SUBJECT: Forwards rev to 940314 response to NRC 931025 RAI re Topical
Rept WPPSS-FTS-131, "Applications Topical Rept for BWR
Design & Analysis."

Subject: **NUCLEAR PLANT NO. 2, OPERATING LICENSE NPF-21
REVISED RESPONSE TO REQUEST FOR ADDITIONAL INFORMATION
REGARDING TOPICAL REPORT WPPSS-FTS-131, "APPLICATIONS
TOPICAL REPORT FOR BWR DESIGN AND ANALYSIS" (TAC NOS.
M77048 AND M81723)**

**REVISED RESPONSE TO REQUEST FOR ADDITIONAL INFORMATION REGARDING
TOPICAL REPORT WPPSS-FTS-131**

**REVISED RESPONSE TO
REQUEST FOR ADDITIONAL INFORMATION
WASHINGTON PUBLIC POWER SUPPLY SYSTEM
TO REVISION 1 OF TOPICAL REPORT WPPSS-FTS-131**

**Figure 27-1 FWCF Results for 47% Power and
106% Flow, RPT Operable, Tech.
Spec. Scram Time**

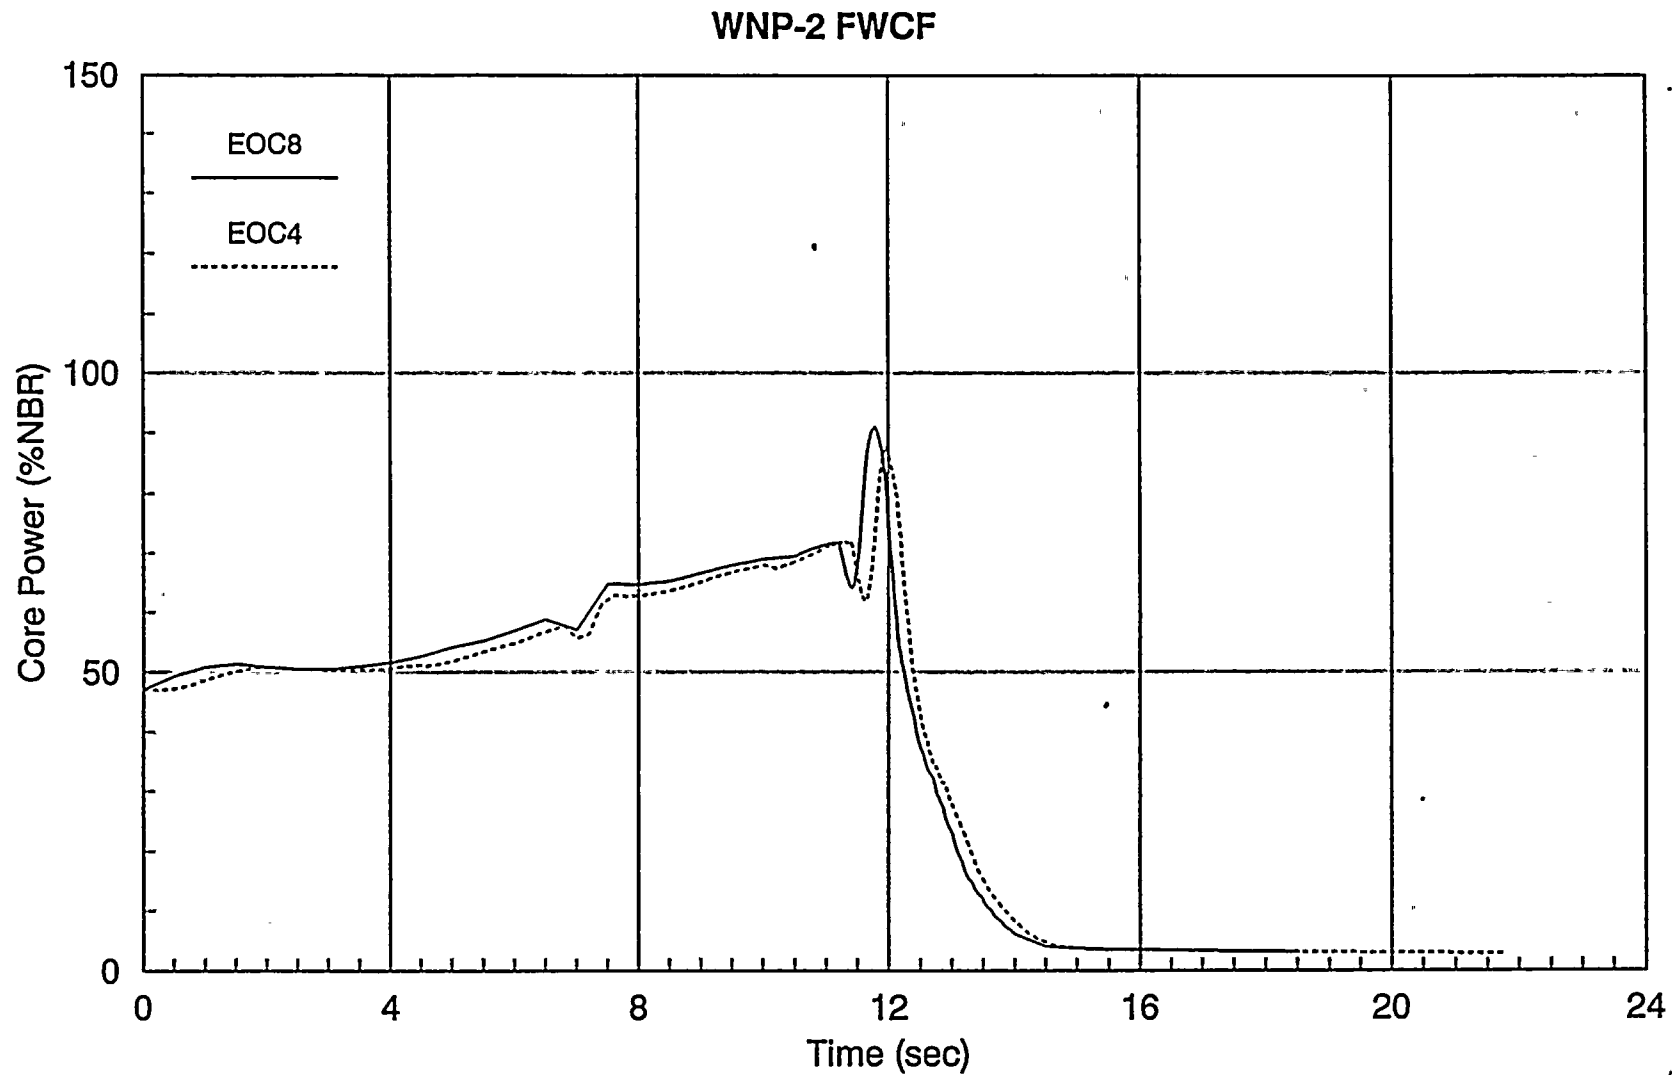
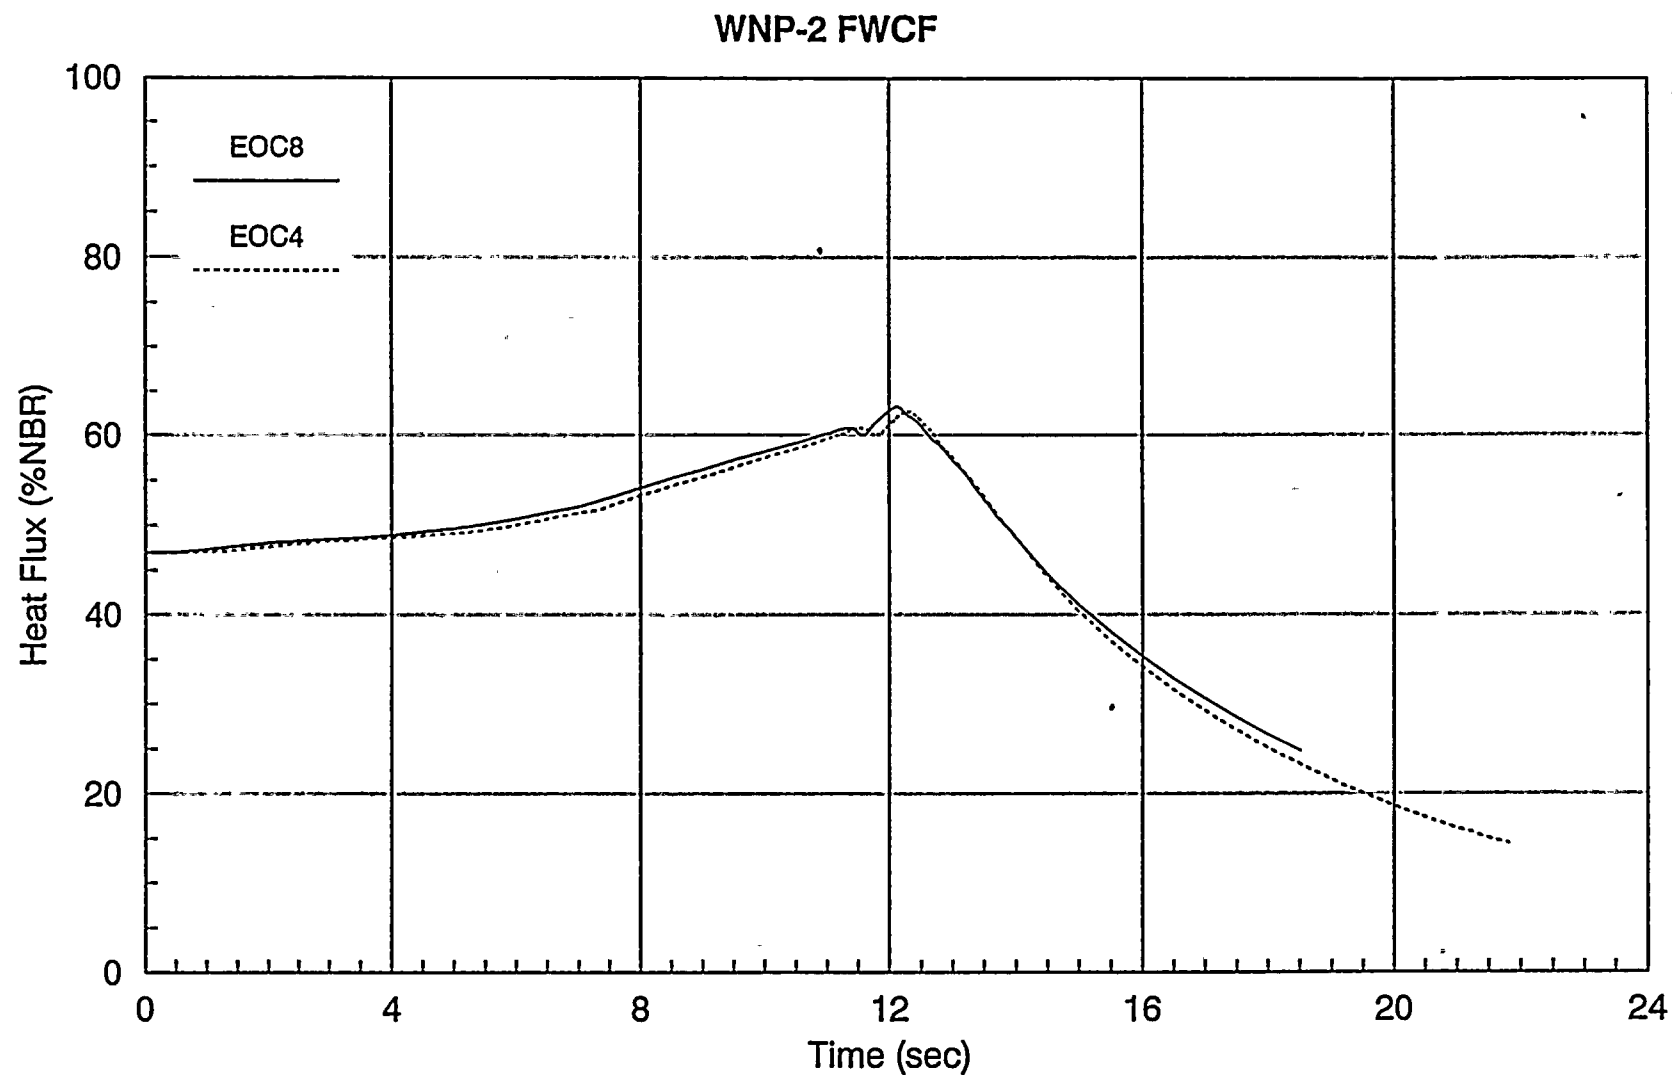
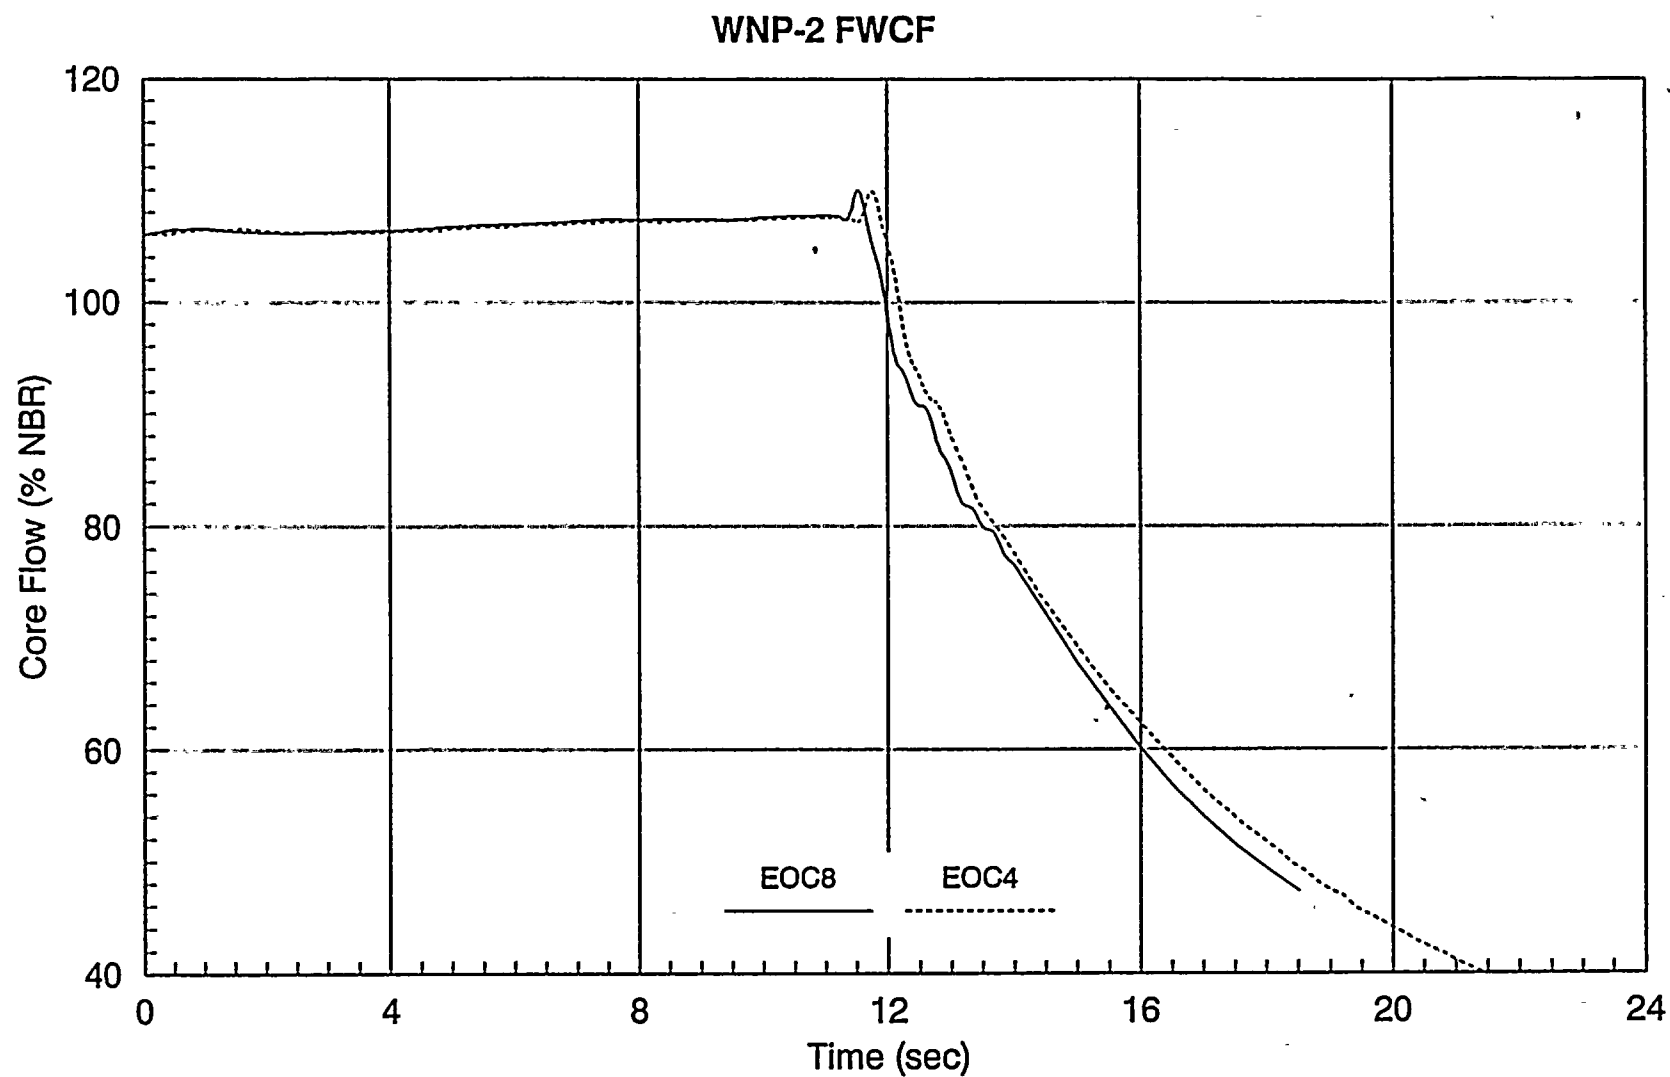
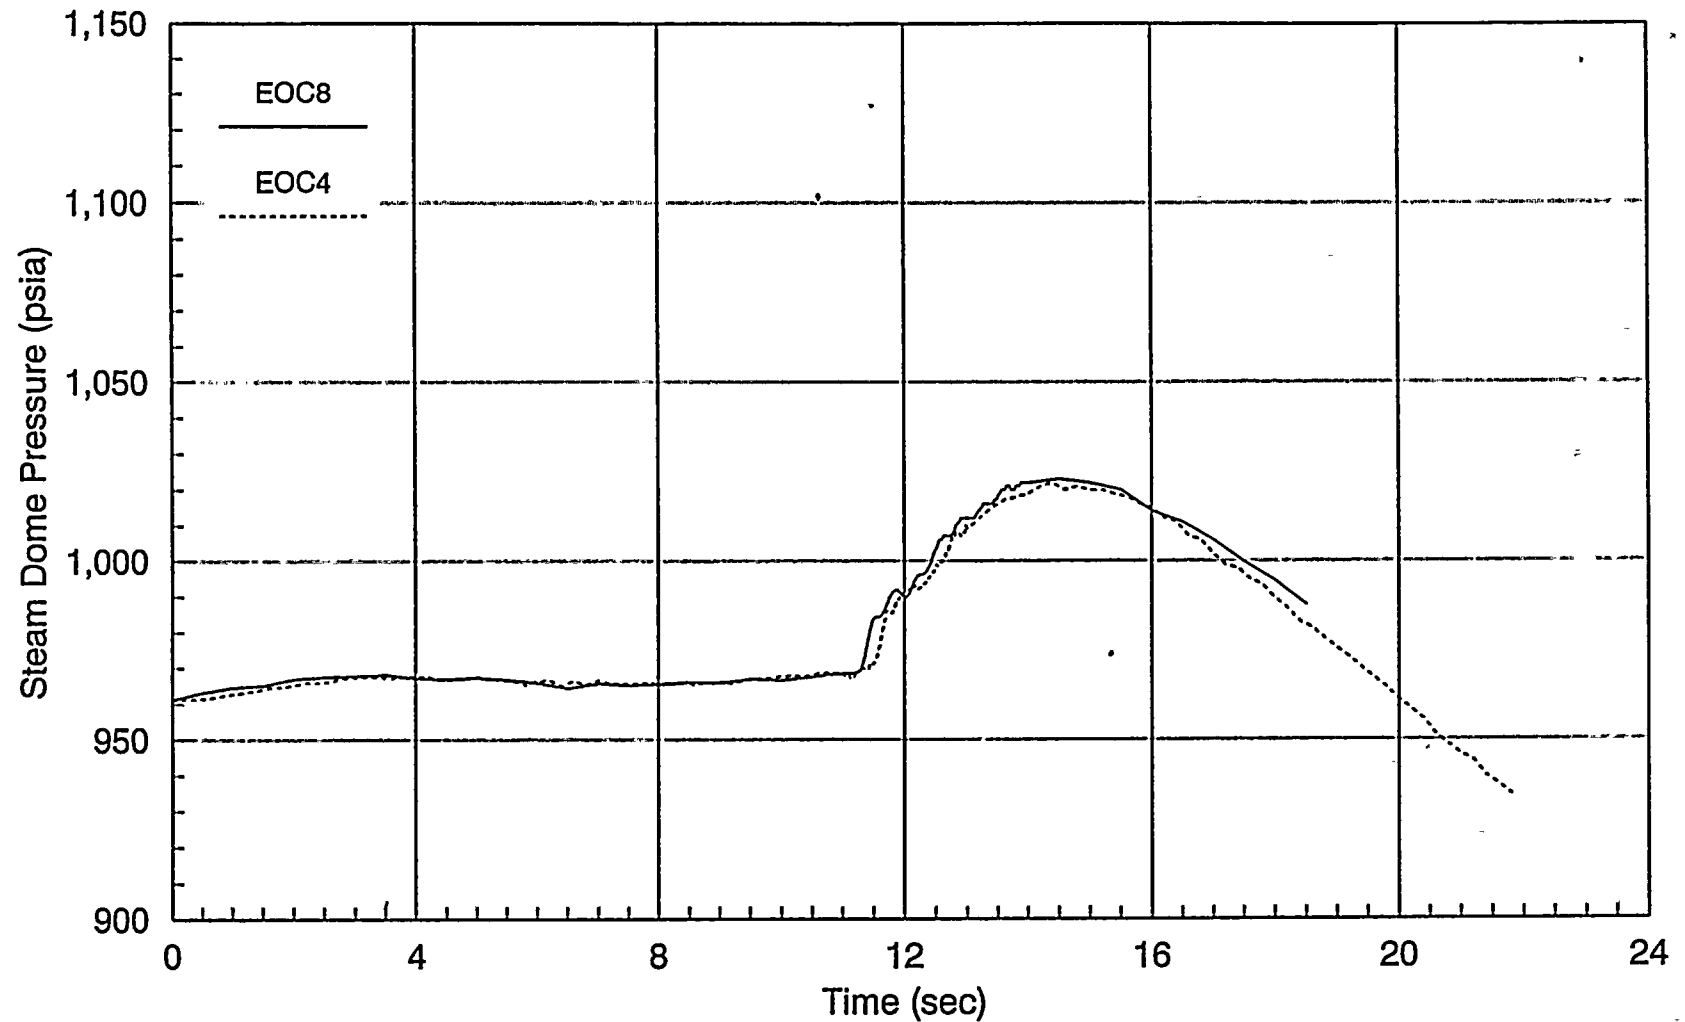
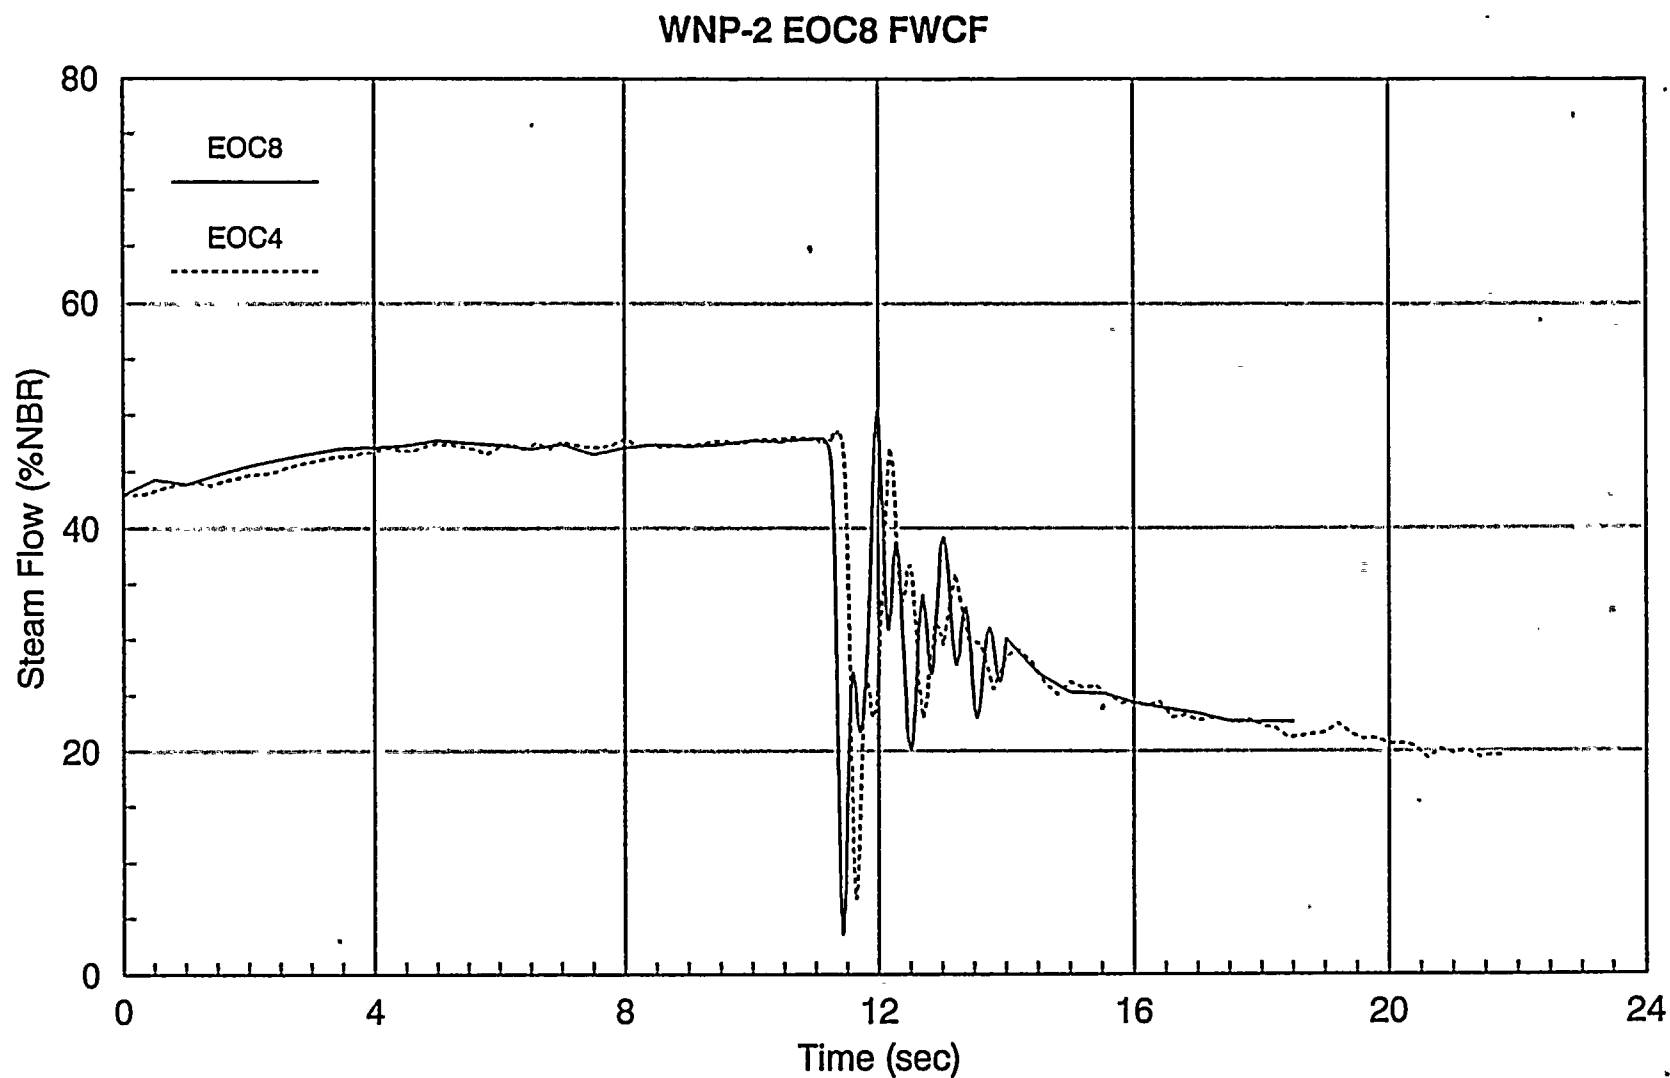
For the Feedwater Controller Failure event, there are dramatic differences between the results presented in Rev. 0 and Rev.1. Explain thoroughly these differences (shown on Tables 5.3.7-3 and 4 in Rev. 0 and Tables 5.3.7-4 and 5 in Rev. 1), and provide a complete set of plots comparing these two sets of analyses.

Improvements and corrections were made to the RETRAN-02 and VIPRE-01 models for WNP-2 after the Cycle 4 simulations were completed. The changes to the RETRAN-02 systems model included: vendor-based gap conductance methodology using the NRC approved RODEX2 code (see Applications Topical Report Revision 1); use of nominal recirculation pump inertia (see Response to Question 17); and mixed core modeling (see Response to Question 16). The initial water level at 104% power for the Cycle 8 analysis was a conservative value of low water level alarm L4 instead of the nominal level that was used in the Cycle 4 simulation. This causes a shift in turbine trip time as can be seen in Figures 27-8 through 27-14. The initial water level for the 47% power cases was set at L4 for both the Cycle 4 and Cycle 8 analyses. Also, the Cycle 4 analysis at 104% power used 100% core flow while the Cycle 8 analysis used 106% core flow.

The changes to the VIPRE-01 hot channel model are the use of vendor-based gap conductance and correction to the heated length calculation for the CPR correlation.
